FINAL
AS-BUILT BASELINE
MONITORING REPORT (MY0)

HERON STREAM AND WETLAND MITIGATION SITE
Alamance County, North Carolina

Subject: Heron Stream and Wetland Mitigation Site: As-built DMS comment response
DMS Contract #: 7192; DMS Project ID: 100014; RFP # 16-006990

FIGURE
2

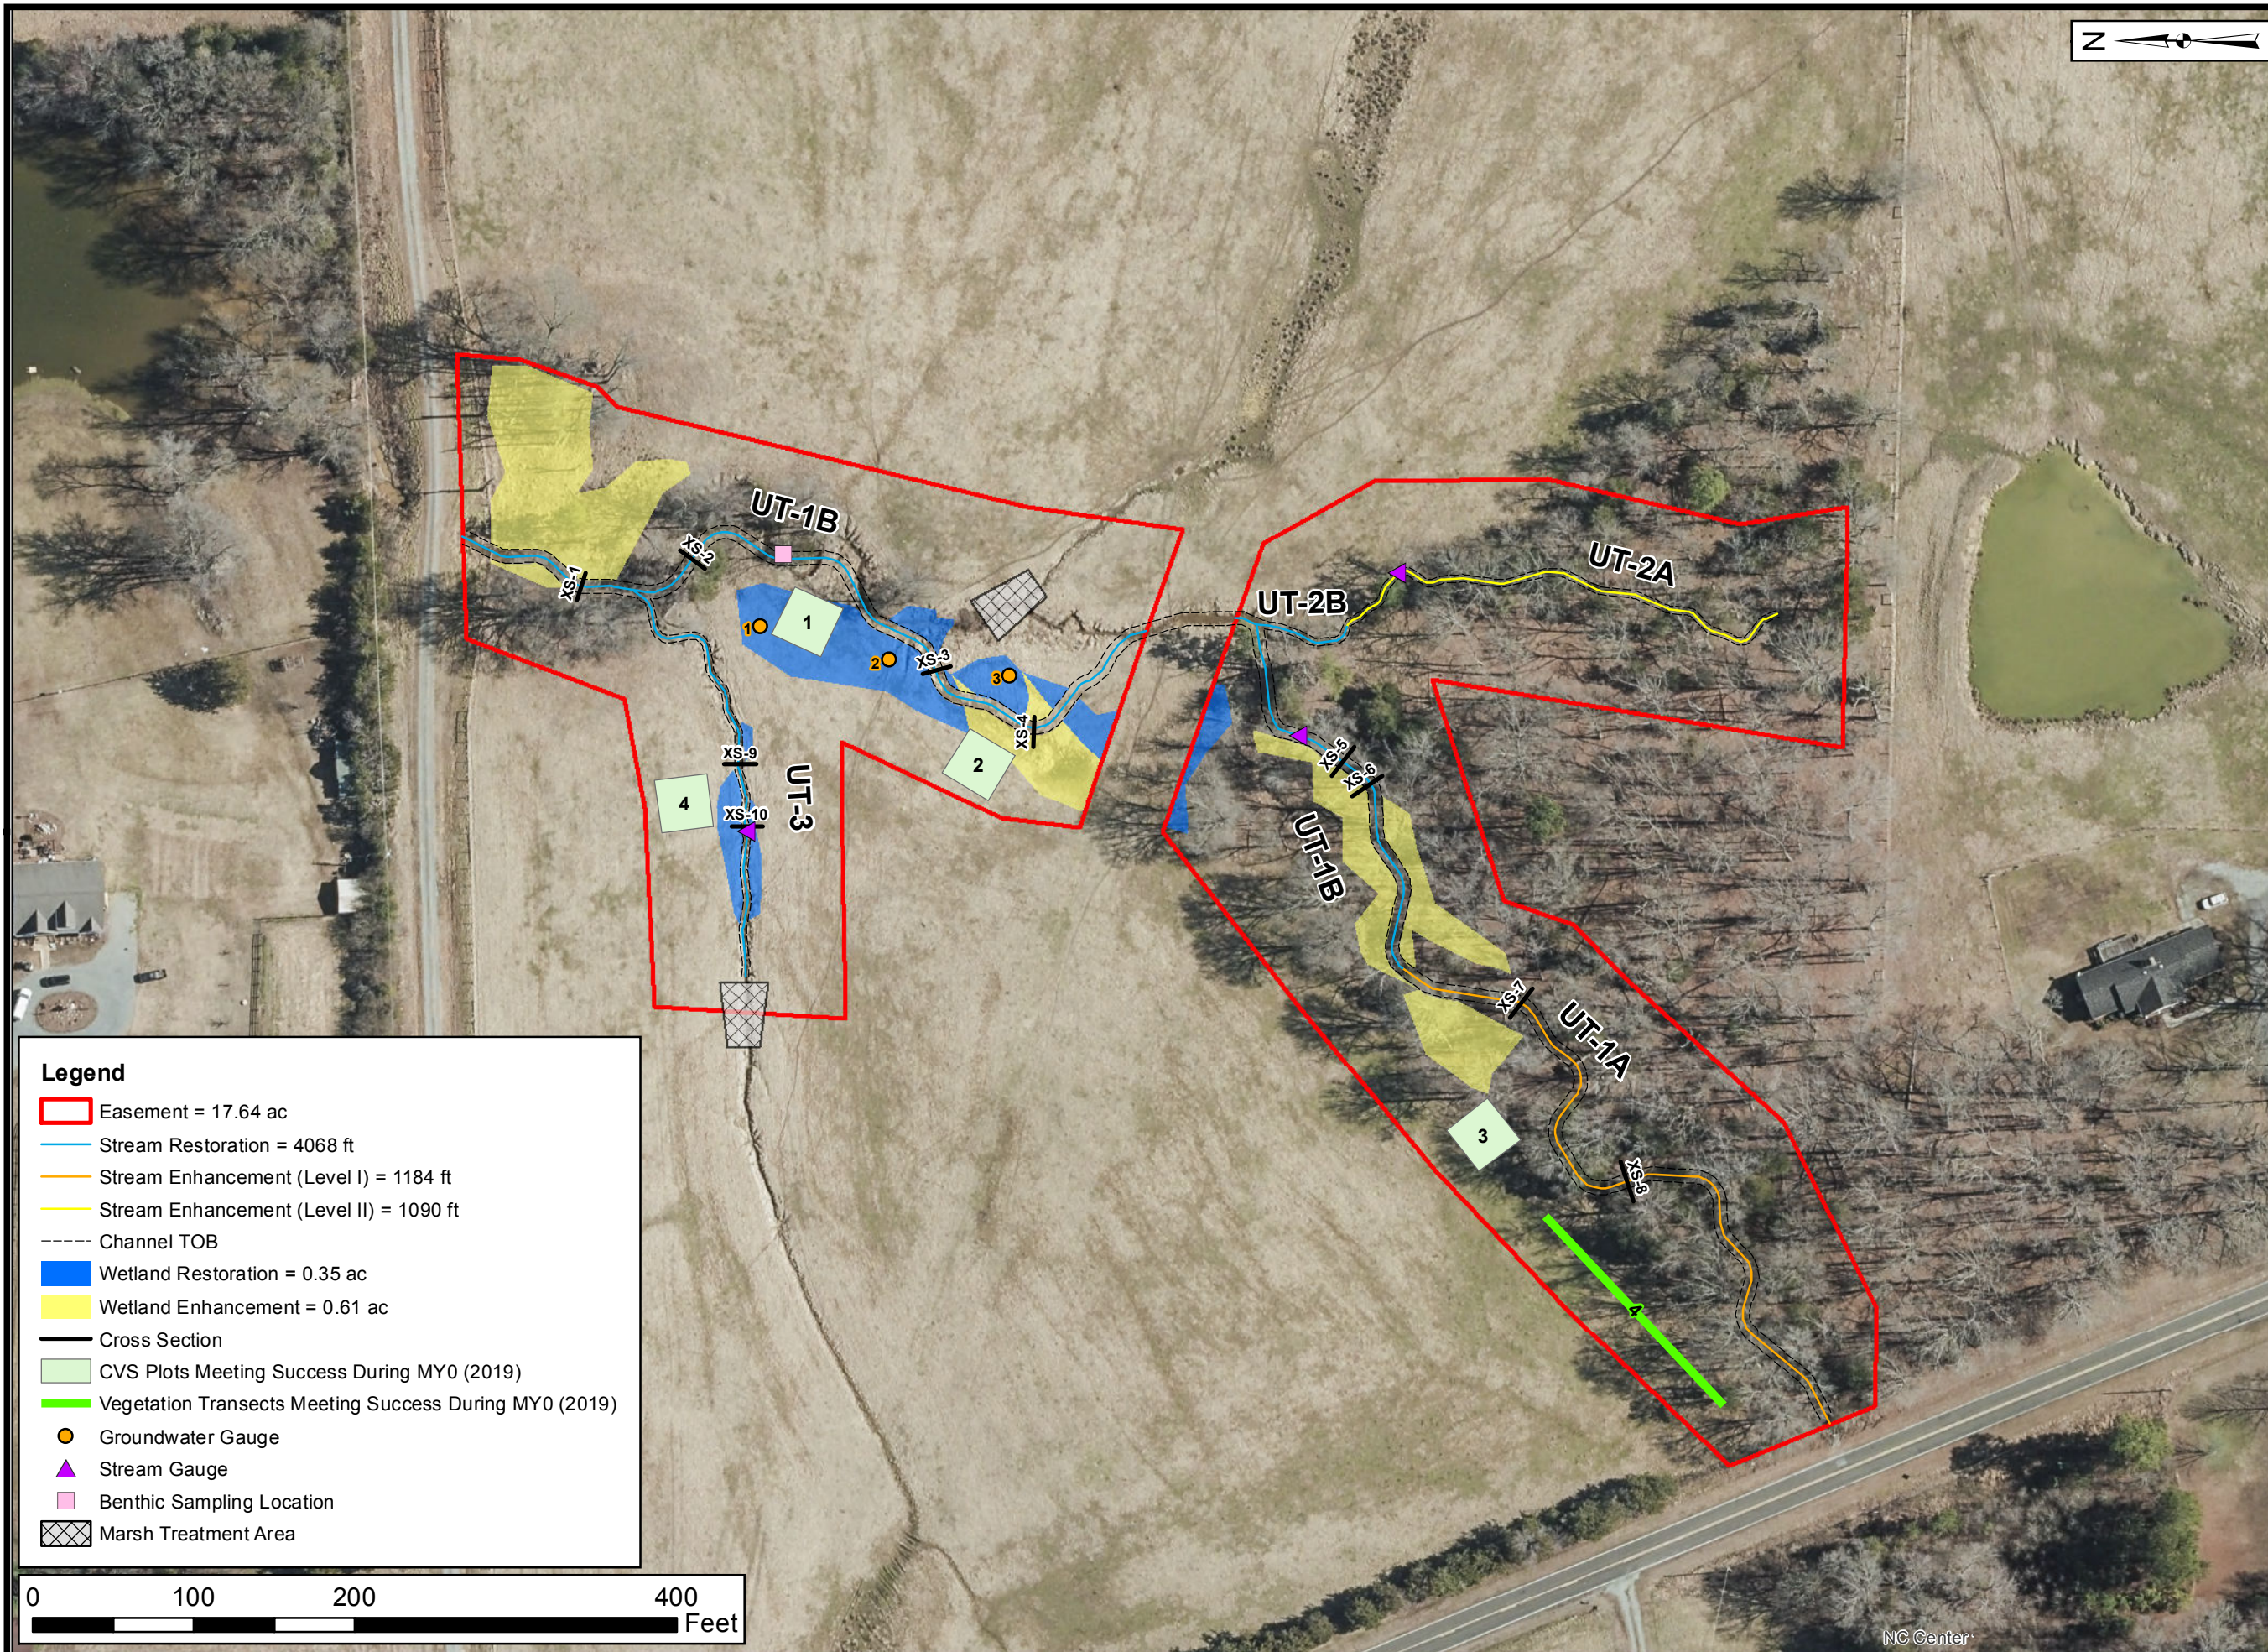
2. CCPV- Figure 2, label stream reaches on overview map that includes all project polygons and figures 2A-D. Revise stream shown on map to break out by restoration level and label reaches to match Reach ID on Table 1.

[Figure 2, and 2A to 2D have been updated.](#)

SHEET NAME	SHEET NUMBER
AS-BUILT STRUCTURES	5
PROJECT NAME:	HERON STREAM AND WETLAND RESTORATION SITE
COUNTY:	ALAMANCE
DATE:	2019

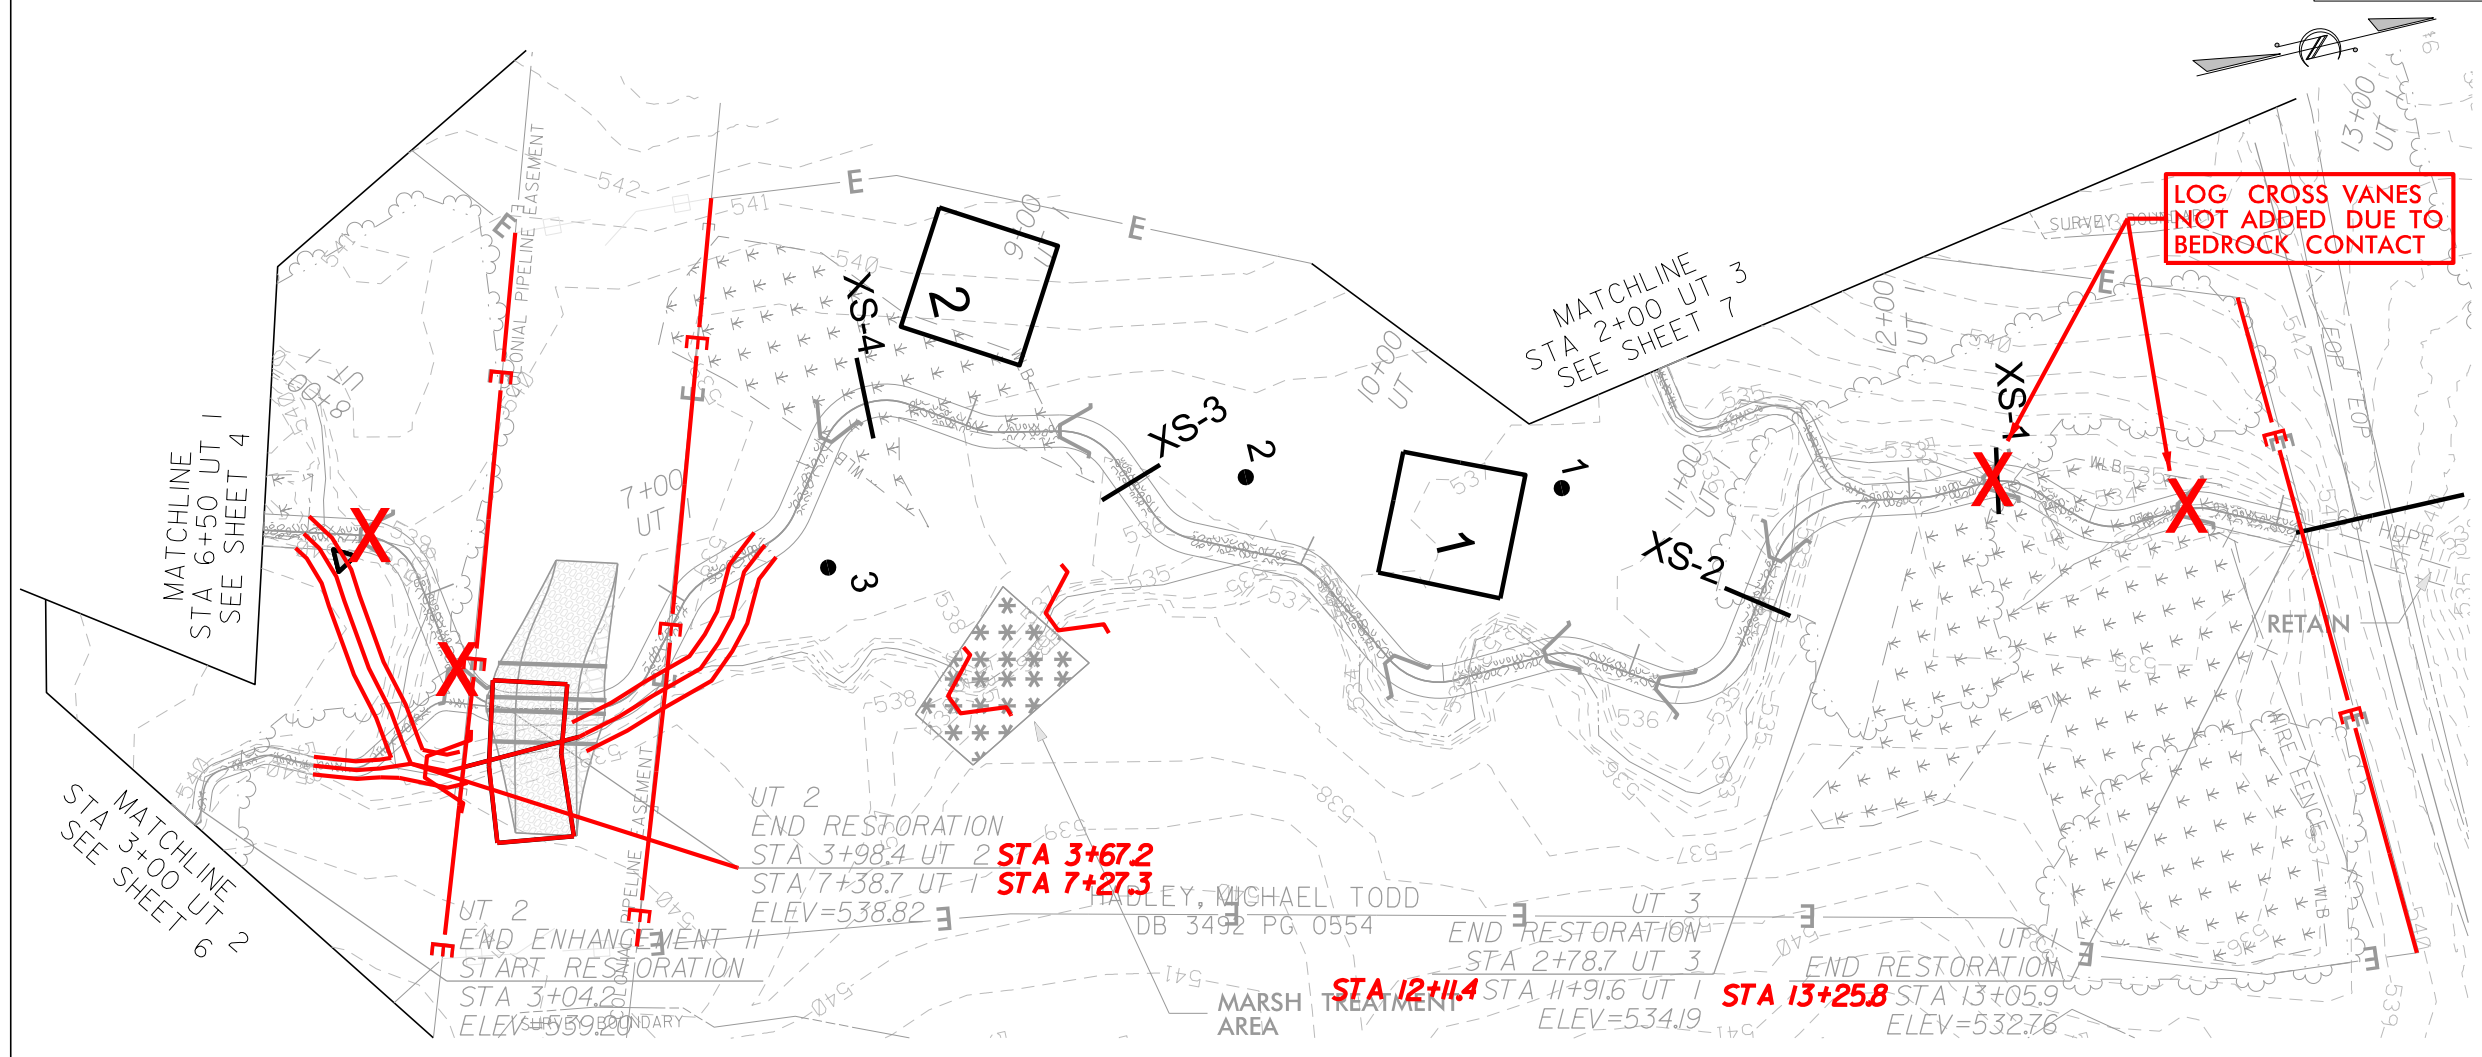
-UT1-, -UT2- STREAM ALIGNMENT, STRUCTURE LOCATIONS AND STREAM CROSSING ADJUSTED DUE TO GAS LINE CONFLICT. EXISTING STREAM ELEVATIONS USED FOR AREA INSIDE OF COLONIAL PIPELINE EASEMENT
